**STATE OF FLORIDA
DEPARTMENT
OF
ENVIRONMENTAL PROTECTION**

**Electric Power Plant Site Certification
Staff Analysis Report**

**Florida Power & Light Company
Turkey Point
Unit 3 & 4 Nuclear Uprate Project**

**PA 03-45A2
DEP OGC Case No. 08-0089
DOAH Case No. 08-00378 EPP**

Figure 5. Turkey Point Plant Cooling Canal System (2008 Yahoo! Inc., identifiers added by SCO)

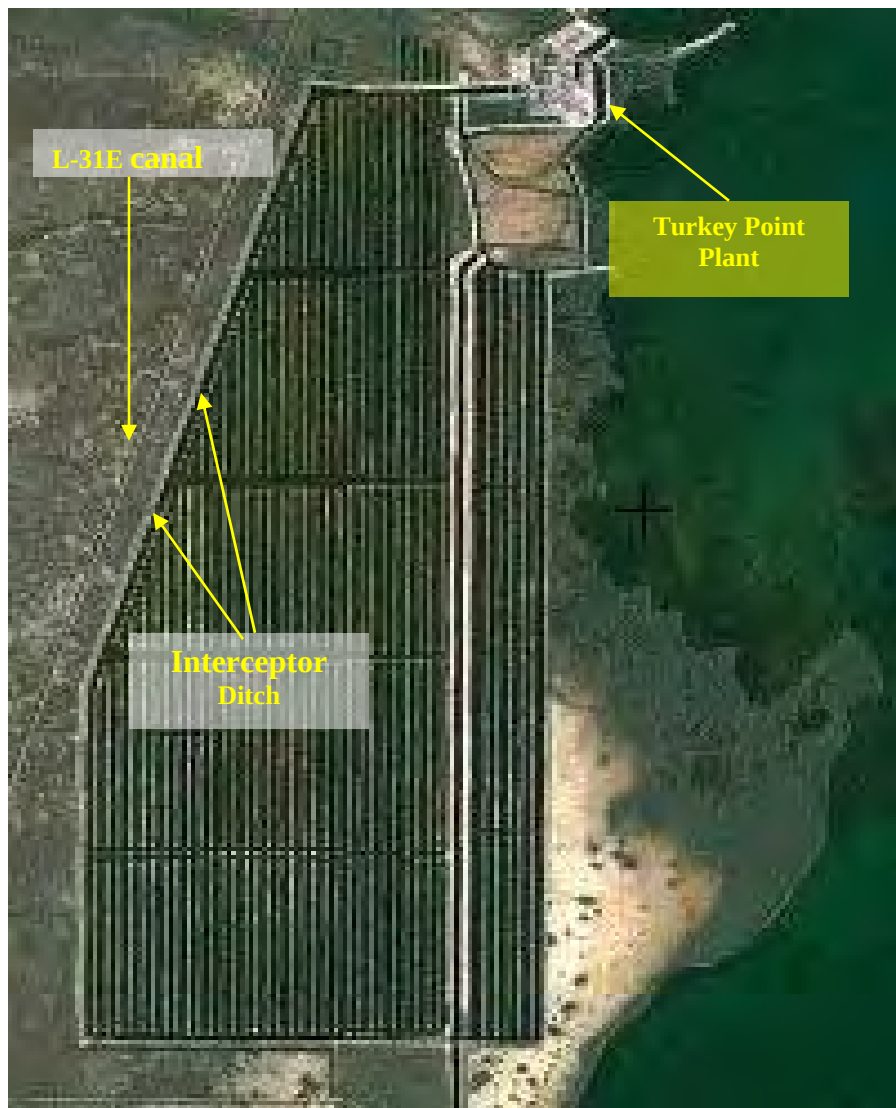
- An Interceptor Ditch (shown in Figure 5) located along the western edge of the CCS was constructed to prevent seepage from the CCS from moving towards the west. Pumps are used to maintain water levels in the Interceptor Ditch below water levels in the L-31E Canal located to the East (also shown in Figure 5). Pumping water from the Interceptor Ditch to the cooling canals creates a lower head to the east, thereby keeping water flowing in an easterly direction. This helps to maintain fresh or potable water to the west of the Interceptor Ditch.

- Because of the circulation water pumps, water levels in the eastern or intake side of the CCS remains lower than that of Biscayne Bay. The resulting head difference keeps water from the CCS from entering Biscayne Bay.

FPL is currently modeling the exchange of saline water between the cooling canals, Biscayne aquifer and Biscayne Bay using available monitoring data and 2-dimensional ground water modeling. In its agency report, the SFWMD pointed out that it is working on a number of restoration activities through the Comprehensive Everglades Restoration Plan Biscayne Bay Coastal Wetlands Project and have concerns related to potential secondary impacts on both the Biscayne aquifer and Biscayne Bay. The District further indicated that the FPL modeling efforts may be insufficient due to limited data and outdated monitoring network design. Miami-Dade County has also expressed concerns regarding potential ground water impacts from the CCS and consistency of the project with the Comprehensive Everglades Restoration Project.

Both SFWMD and Miami-Dade County have recommended that FPL be required to conduct revised monitoring and analysis utilizing a more modernized approach as a condition of certification for the project. The SFWMD has also suggested the incorporation of baseline data collected prior to implementation of the uprate project.

Figure 7. Crocodile Nest Locations 1978-2006 (SCA, Figure 2.3.6-1)

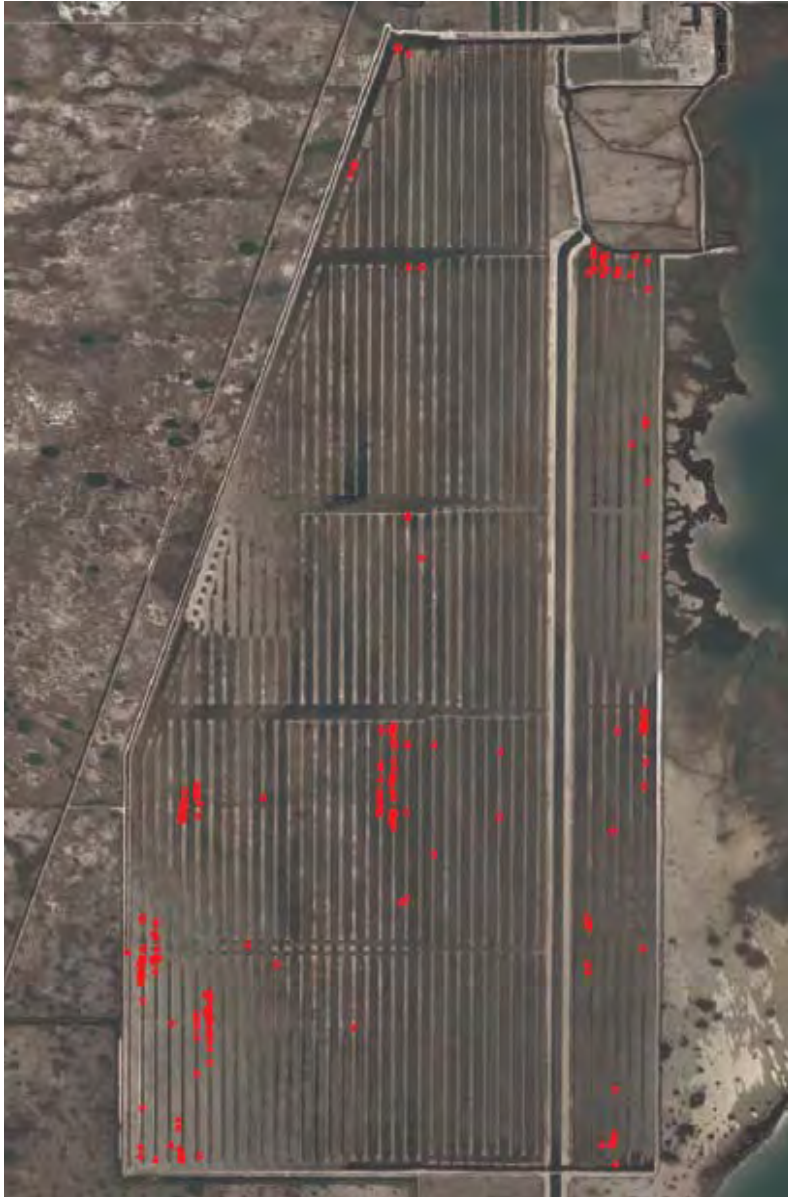
and post-uprate monitoring. If analyses show a negative effect on crocodile populations within the CCS, then it is also recommended that monitoring should be conducted outside of the system to determine the “net” effect on the Turkey Point population.

Both Miami-Dade County and the FWC expressed concerns over the potential negative impacts of increased water temperature and salinity within the cooling CCS on the crocodile population within their agency reports.
